California Regional Water Quality Control Board

**SUBJECT: ADDITIONAL COMMENTS ON THE JOINT TECHNICAL DOCUMENT
FOR GREGORY CANYON LANDFILL DATED JUNE 2003**

**RESPONSE TO STATE WATER RESOURCES CONTROL BOARD
LETTER DATED MAY 7, 2002
GREGORY CANYON LANDFILL
SAN DIEGO COUNTY, CALIFORNIA**

FIGURE 4

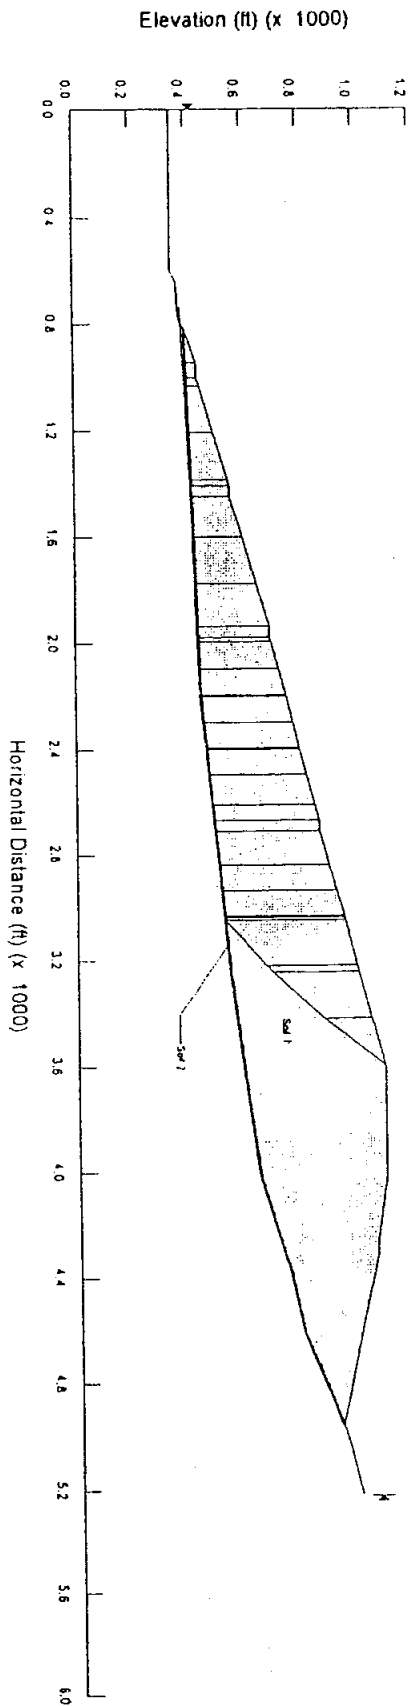
Page 3, Figure 4

Slope stability report submittals typically include computer printouts for the analyses/calculations. We prefer having the opportunity to review these printouts rather than simply a summary of the basic input data and analytical results.

6. Table-- The NA on the table for unit weights of the interfaces only indicated that actual data is Not Available. In the analysis, the interface is represented by very thin layer of a material with shear strength properties at the weakest interface in the liner system. A unit weight of 10 pcf was assigned to simulate the weight of small thickness of the materials involved in the interface. In-house analyses using significantly higher unit weight for the layer representing the interface showed no significant change in the calculated factor of safety.

11. Figure 4 – Please see the response to item 6 above. The printout presented in Figure 4 is the output from the computer program. Other files generated by the program provide no usable information.
